# MAC Service Interface

Glen Kramer, Teknovus, Inc.  
glen.kramer@teknovus.com

# Two problems identified

# If 21.5.1 takes precedence...

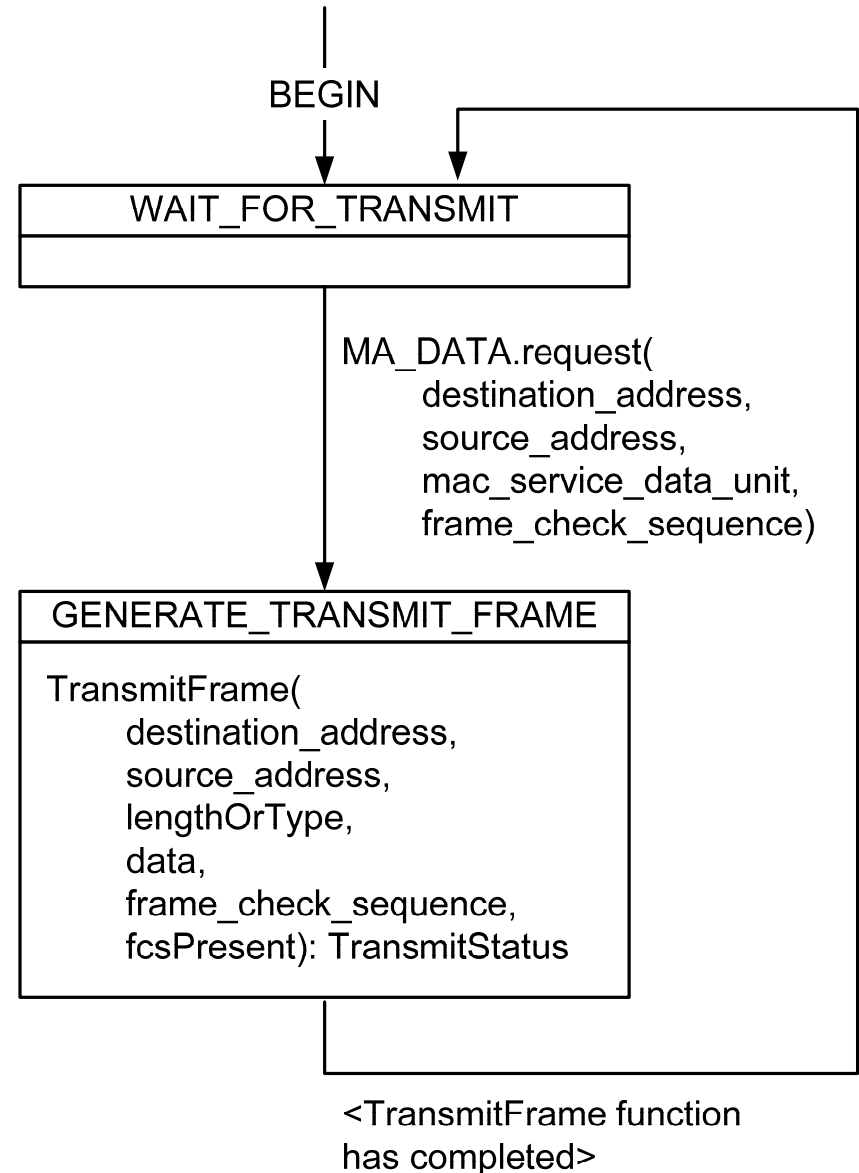
- ... then, the transition from the state should wait for a condition.
- Few ways to specify the condition:
  1. Simply describe it in a note
  2. Add a boolean  
TransmitFrameCompleted
  3. Wait for specific value(s) of  
TransmitStatus

# Option 2: Add a new Boolean

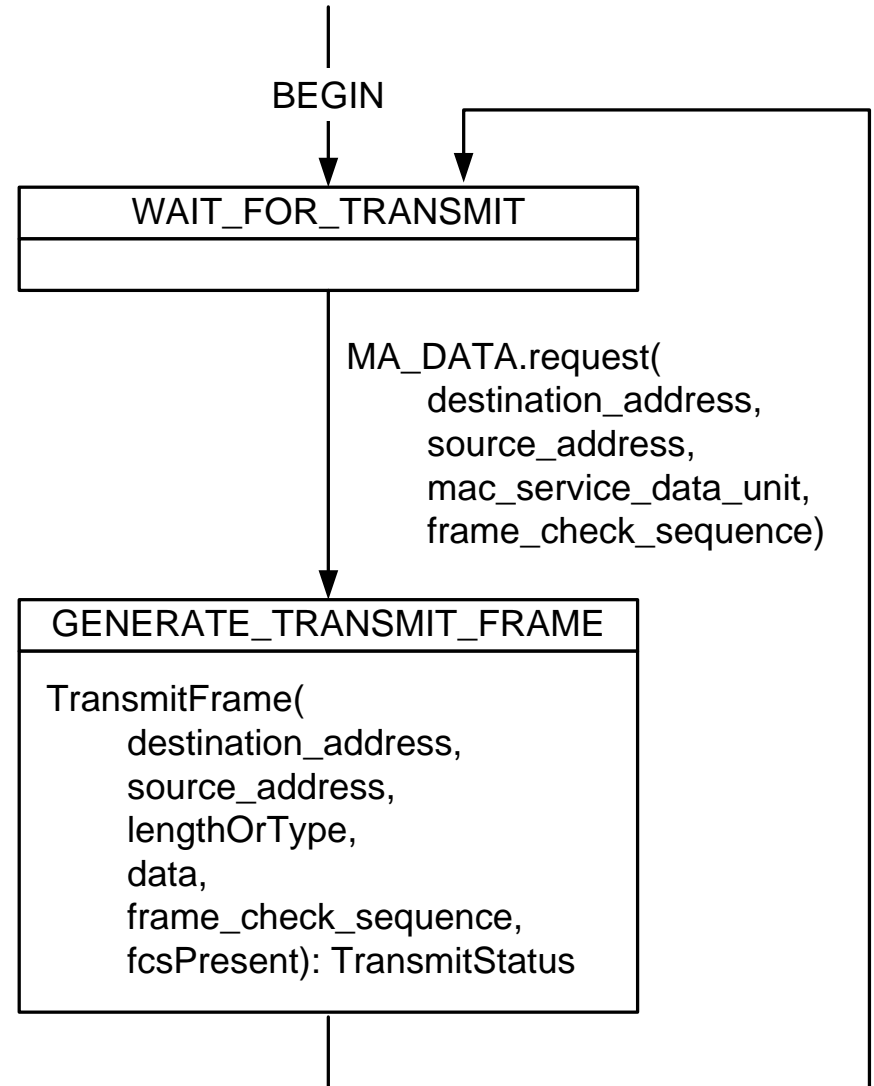
1. Add a boolean  
TransmitFrameCompleted

## TransmitFrameCompleted

This boolean is set to false immediately after TransmitFrame is called and is set to true when TransmitFrame function completes.

TYPE: Boolean

DEFAULT: false

TransmitFrameComplete = true

# Option 3: Wait for a specific TransmitStatus

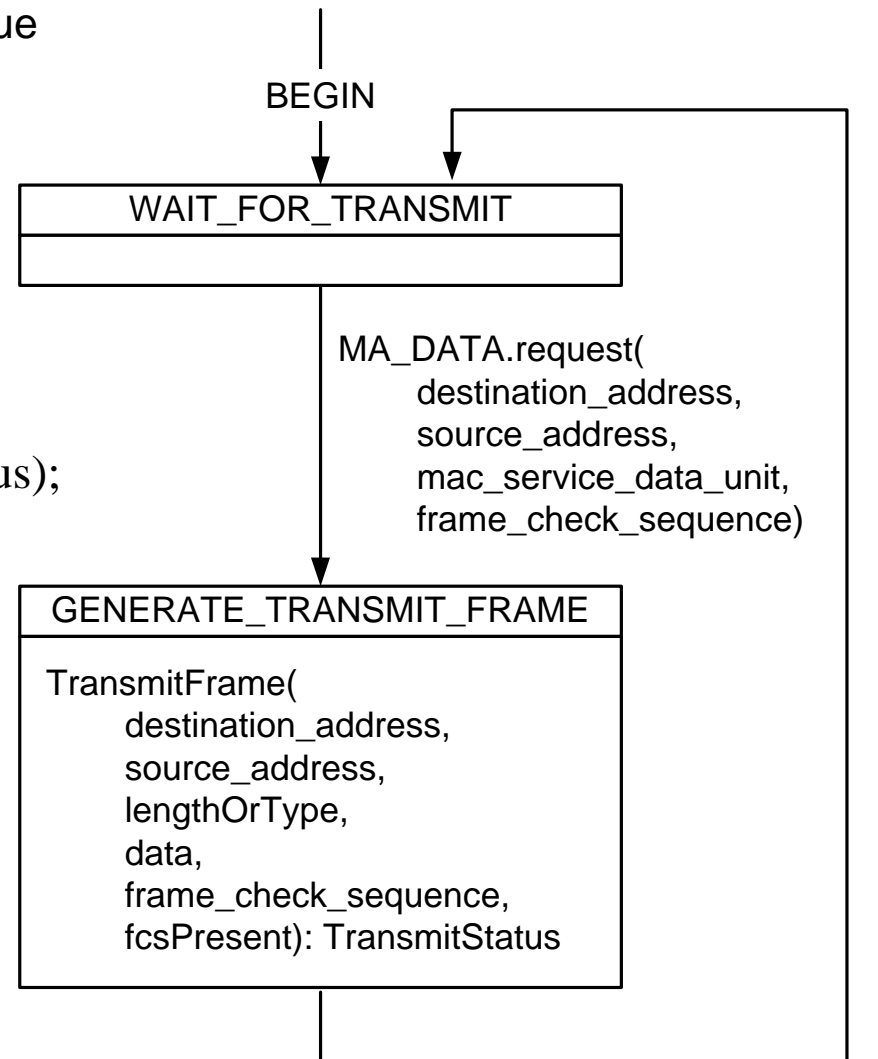
- Wait for specific value(s) of TransmitStatus
  - With this option, we need to specify what value the TransmitStatus variable has before TransmitFrame completes (it should not hold the status of the previous TransmitFrame)

- **Some changes needed to Pascal:**

- TransmitStatus = (transmitInProgress, transmitDisabled, transmitOK, excessiveCollisionError, lateCollisionErrorStatus);

- *function* TransmitFrame (
  - ...
    - begin*
      - TransmitFrame := transmitInProgress
      - if* transmitEnabled *then*
        - begin*
          - TransmitDataEncap;
          - TransmitFrame := TransmitLinkMgmt
        - end*
      - else* TransmitFrame := transmitDisabled
    - end*; {TransmitFrame}

TransmitStatus != transmitInProgress

Figure 2-1

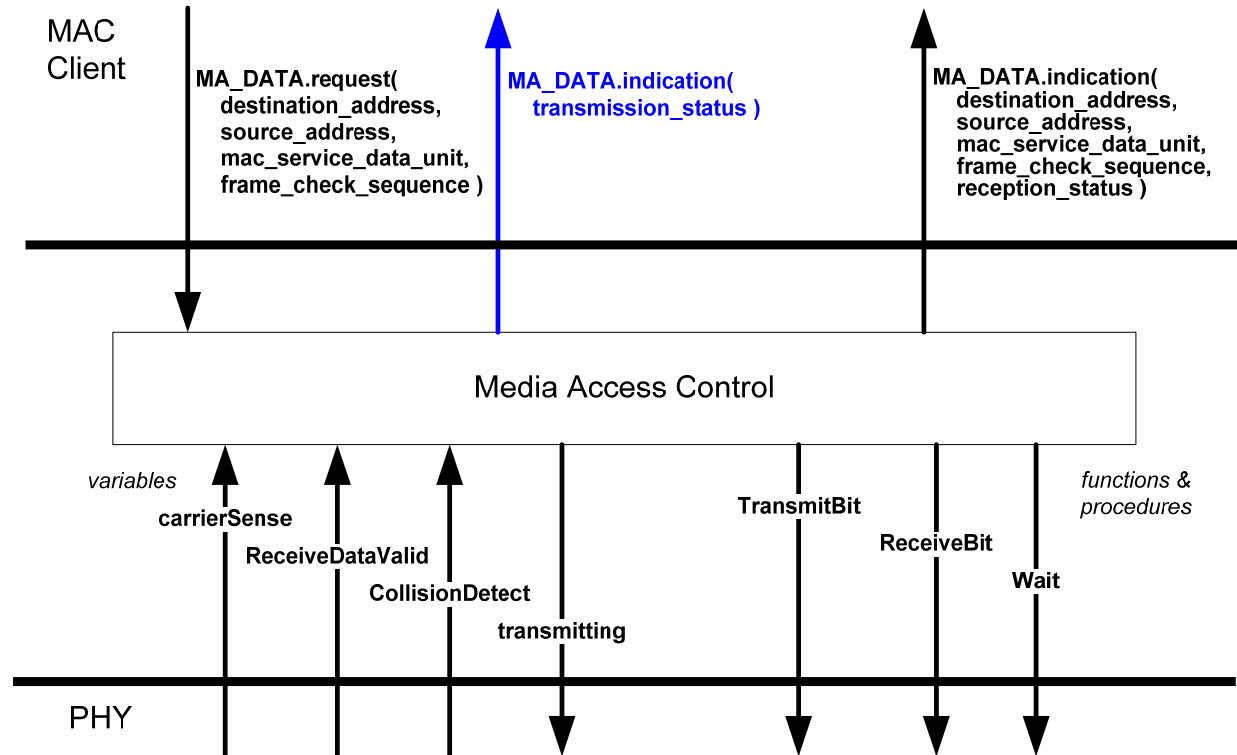
- To let the MAC client know when frame transmission ended, another indication can be added to the MAC Service Interface.

# MAC Client Transmit Interface

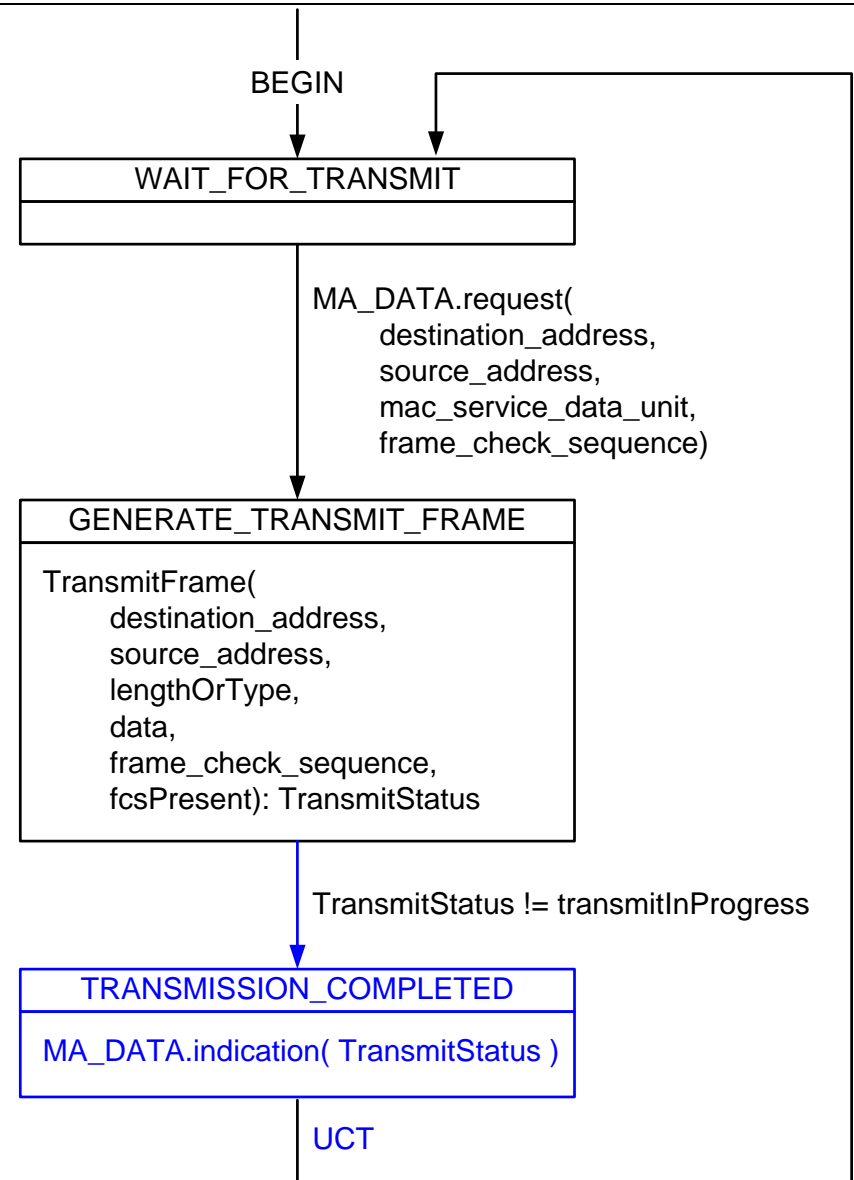
- Modification to Figure 4-6 – MAC Client transmit interface state diagram.
- (This example assumes option 3 is selected, but this is not necessary)

# MAC Client: PAUSE

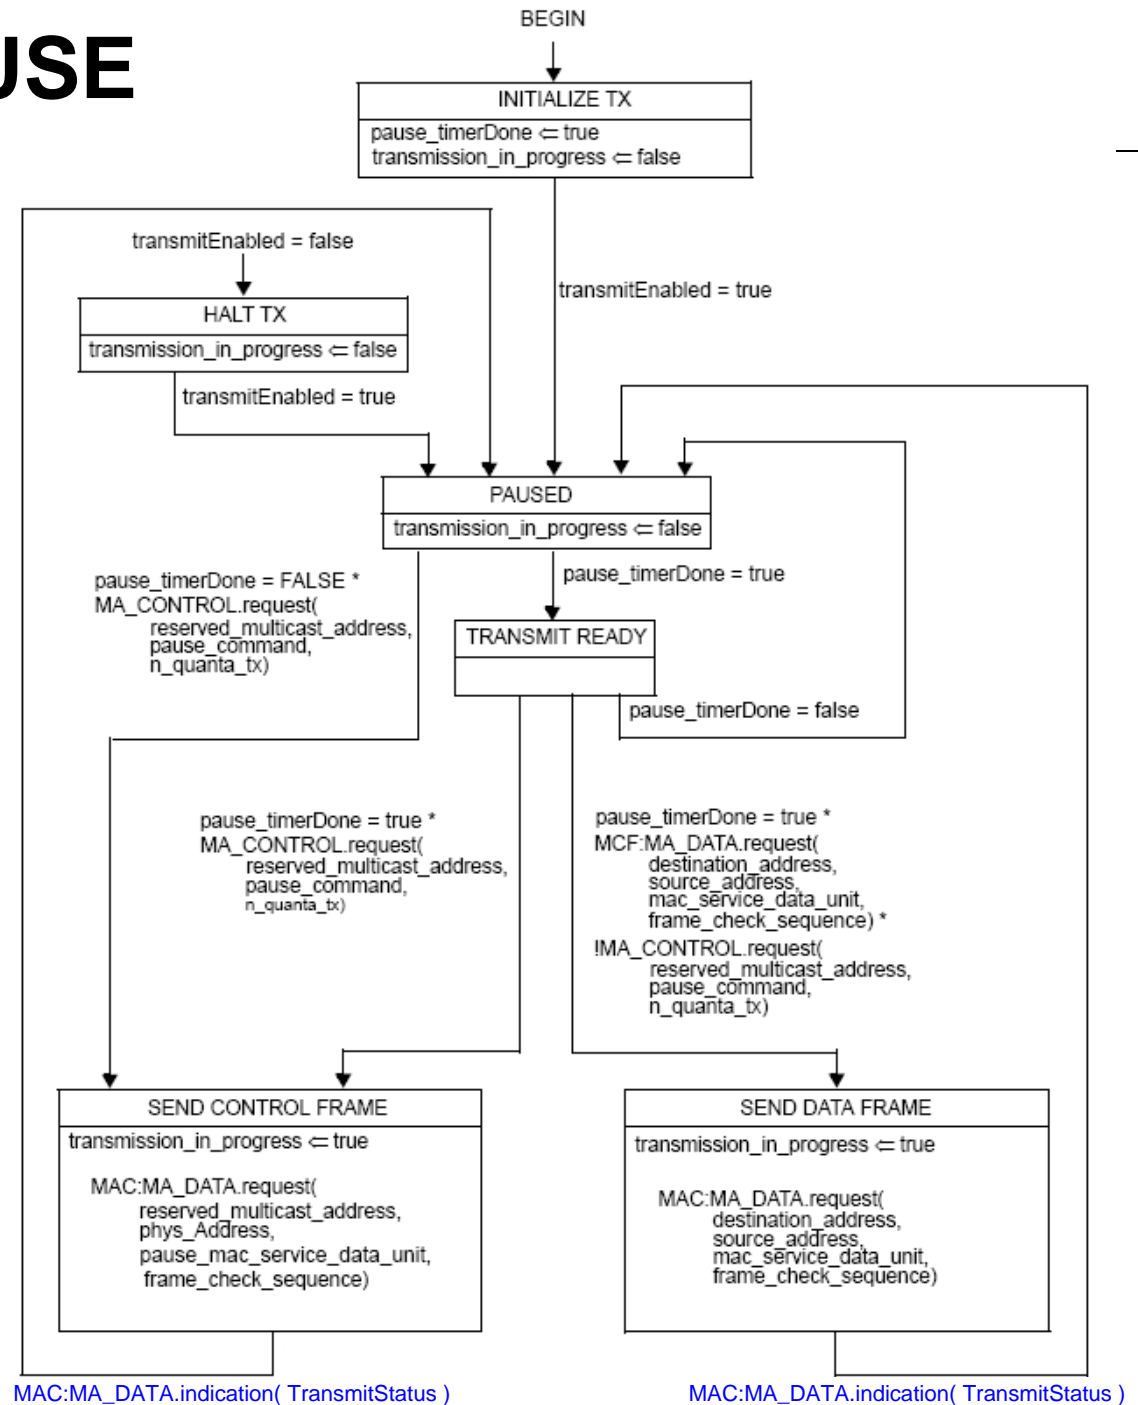
- To pace itself, a MAC client after issuing `MA_DATA.request(...)` would wait for `MA_DATA.indication(TransmitStatus)`
- Example shown for PAUSE Operation Transmit state diagram (Figure 31B-1) →
